**Grangetown: Ninian Park Primary School: School Safety Zone: Sloper Road & Virgil Street**

**Consultation Report**

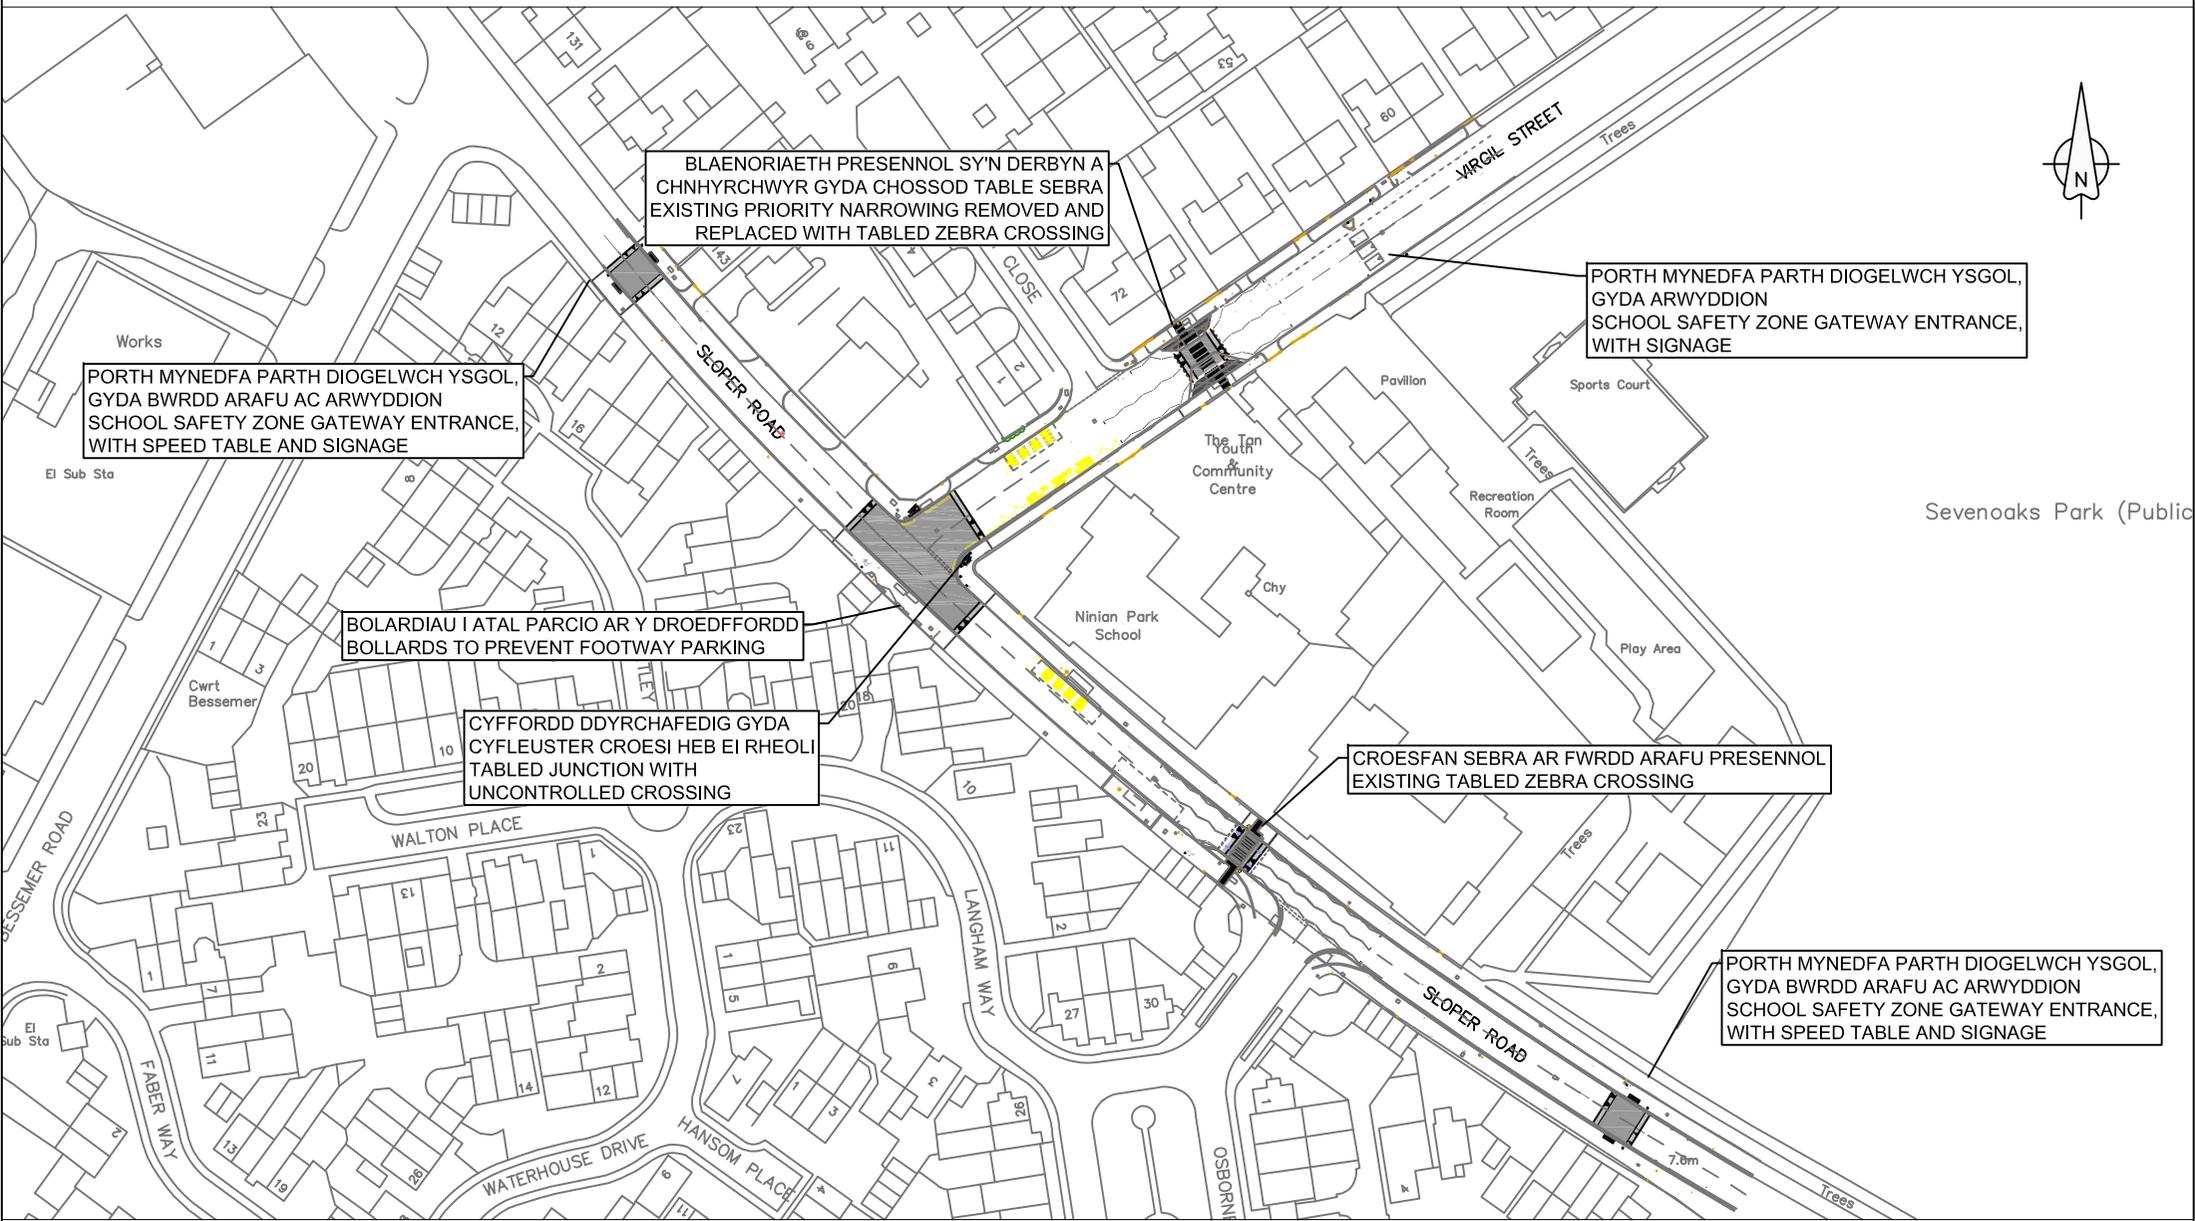
*A resident raised concerns relating to the location of the traffic calming feature on Virgil Street, which may affect future access to their property and their ability to construct a vehicle crossover.*

*Several respondents raised concerns relating to parental parking issues and driveways being blocked. Requests were made for additional restrictions at the entrance to City Gardens, and enforcement of existing restrictions. Concerns were also raised about the potential displaced parking.*

*Pupils from Ninian Park Primary raised concerns about the condition of the road and pavement outside the school.*

This location has been reviewed following the concerns raised by the resident. A 20mph speed limit has recently been introduced which is effective in reducing vehicle speeds on the approach to the school. It has been agreed to retain the existing traffic calming features (speed cushions) in their current position, and not to change these to a full width speed table as shown in the consultation plan. The new school safety zone signs will now be located within the footway, this will ensure that there is sufficient space for the resident to construct a vehicle crossover in the future, subject to the standard application process – details of which can be found on the Council website.

Additional parking and loading restrictions will be introduced following the implementation of this scheme. These will be subject to a separate Traffic Regulation Order process. We will

The footway directly outside the school entrance on Virgil Street will be widened and resurfaced as part of this scheme, this will create a much wider path for pupils and parents to use. The existing zebra crossing near the school entrance on Sloper Road will also be upgraded and widened.
